ITEM # 3.0

PRELIMINARY & FINAL PLAT APPROVAL:

Crystal Estates Ph. IV Subdivision
Being a 14.71-acre parcel of land, out of Lot 27-1,
West Addition to Sharyland
R-2
Developer: DG & GG Investments, LLC
Engineer: Ever Engineering, LLC

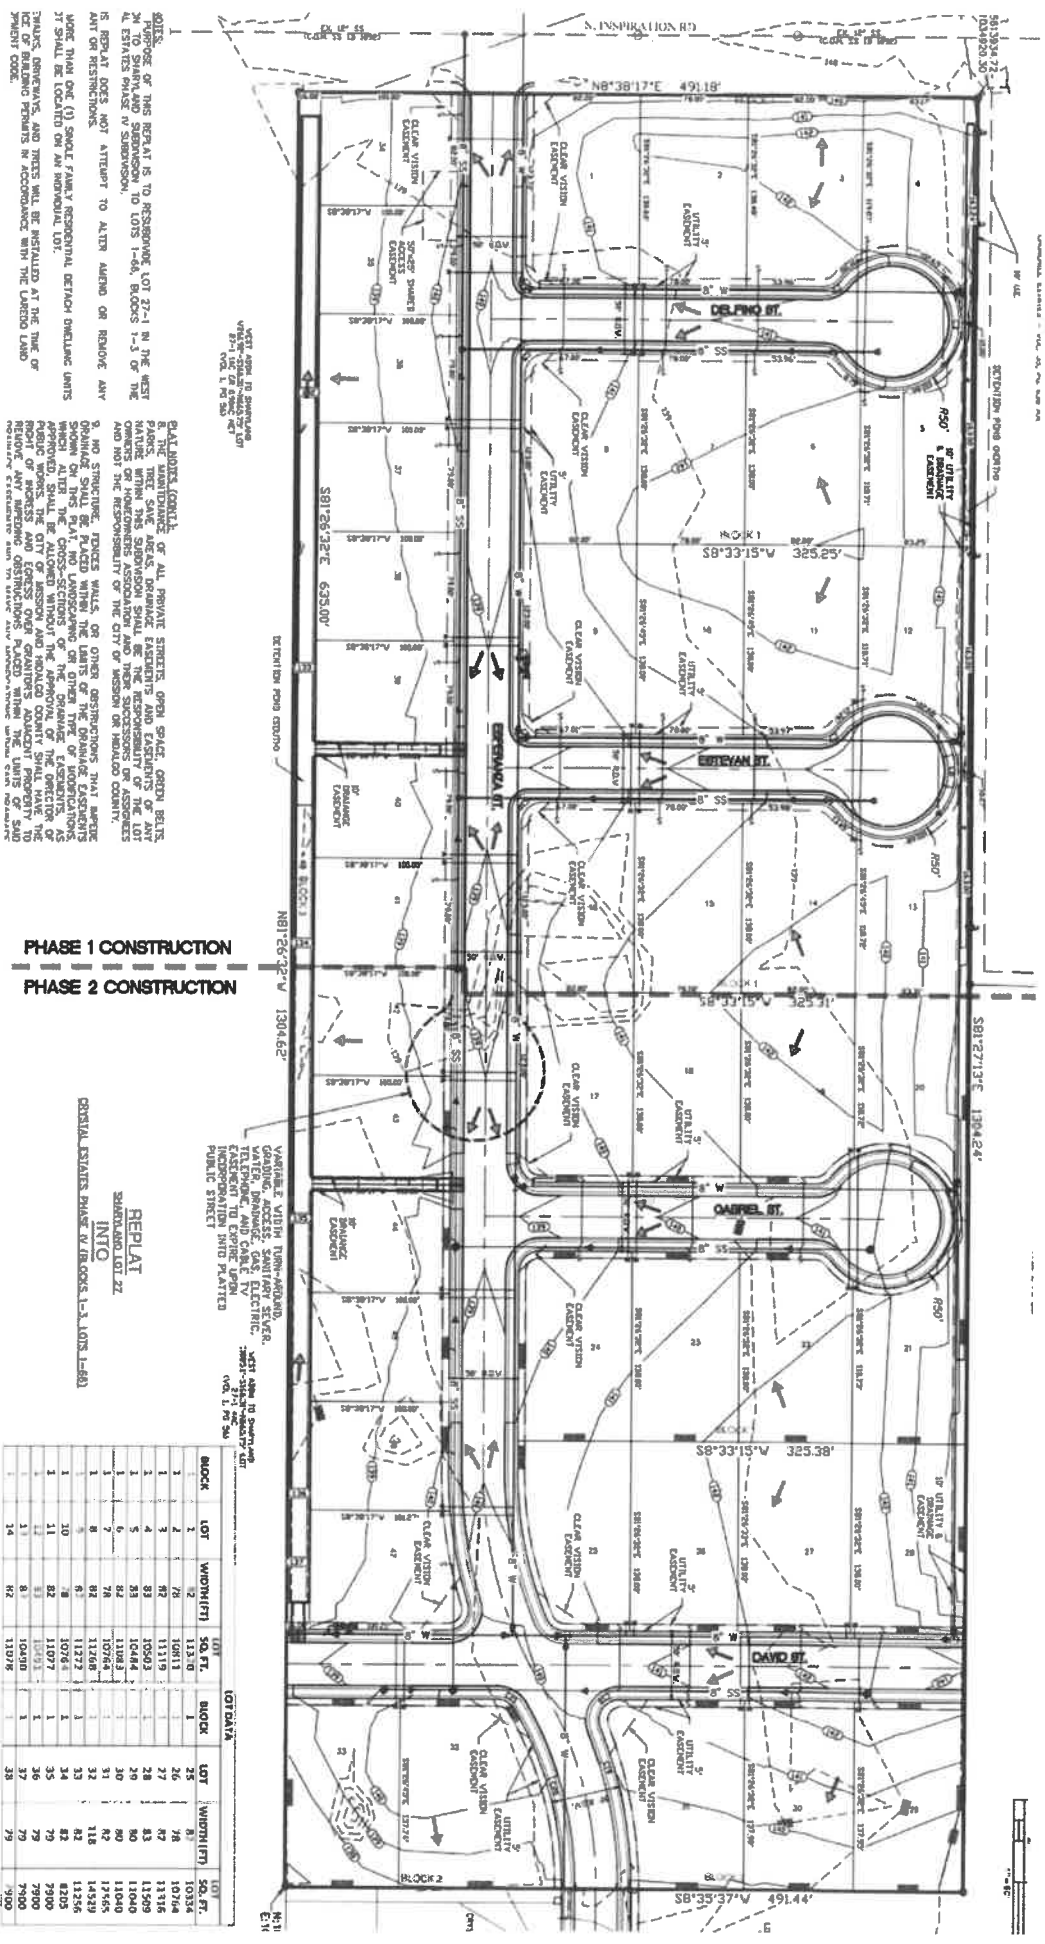
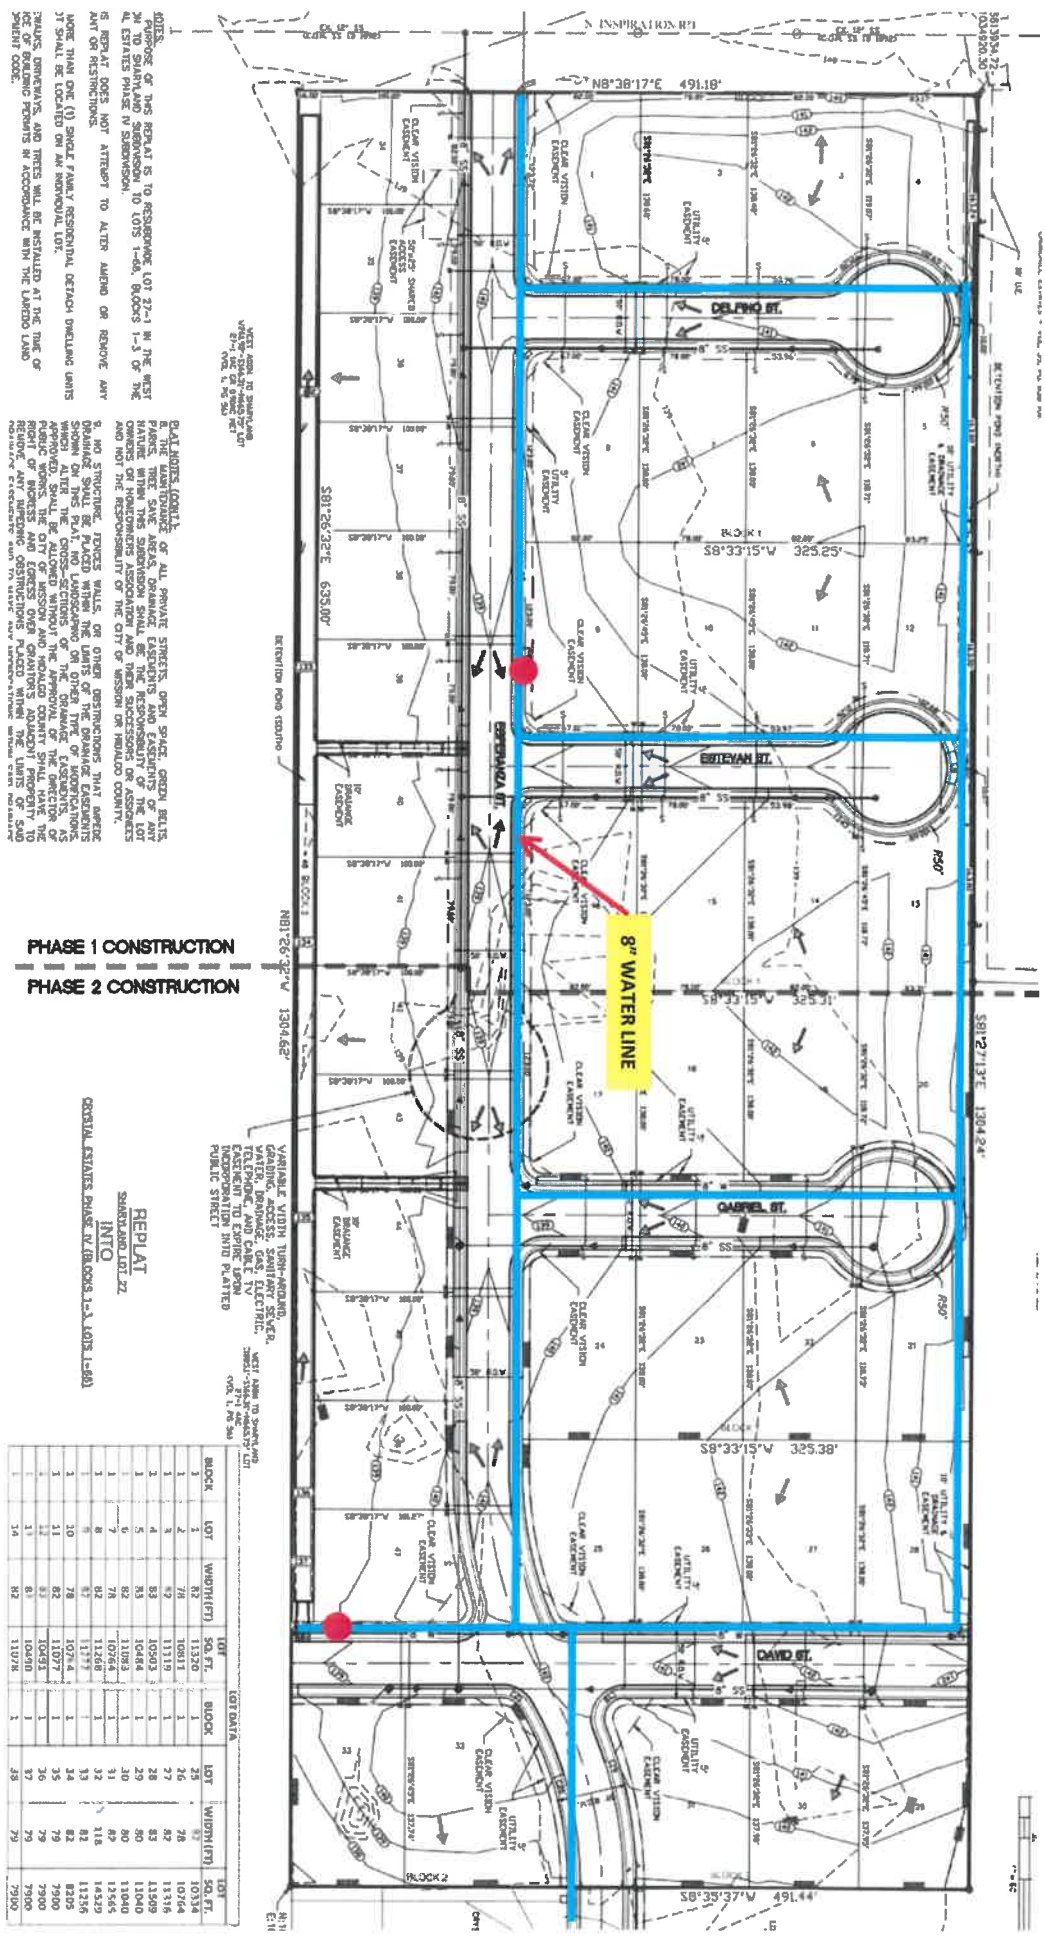
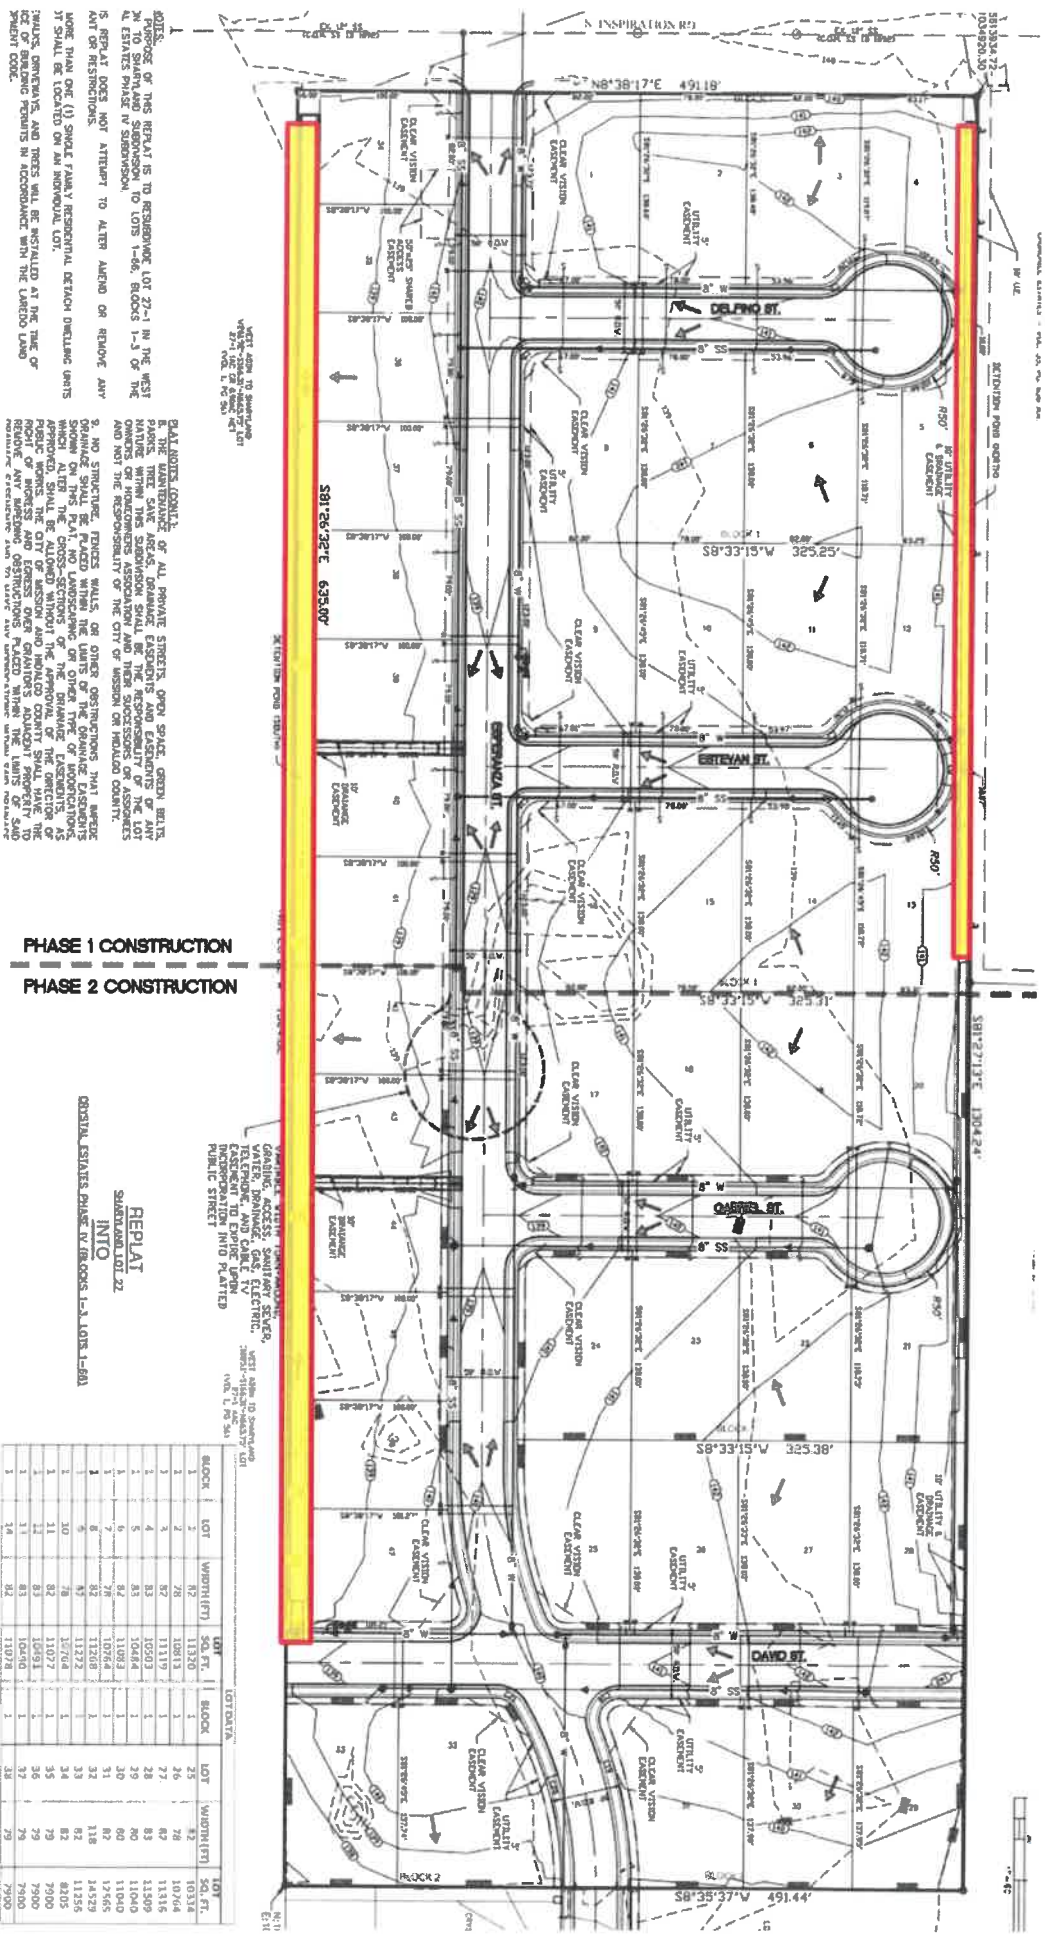
The developer is requesting to change the following street names:
Estevan St. to Glenda St. / Gabriel St. to Britany St. / Teresa St. t Bailey St. / and David St. to Briley St.

*Code of Ordinances / Chapter 98 - SUBDIVISIONS, Sec. 98-134. - Streets. (n) Street names.
Names of new streets shall not duplicate or cause confusion with the names of existing streets, unless the new streets are a continuation of or in alignment with existing streets, in which case names of existing streets shall be used, and shall conform to the existing street naming system.*

1. Payment of Capital Sewer Recovery Fees
2. Payment of Park Fees
3. Water District Exclusion
4. Denial of the requested variance to use suggested street names requested by the owner and apply the City's continued and aligned existing street names as noted on the Code of Ordinances / Chapter 98 - SUBDIVISIONS, Sec. 98-134. - Streets. (n) Street names.
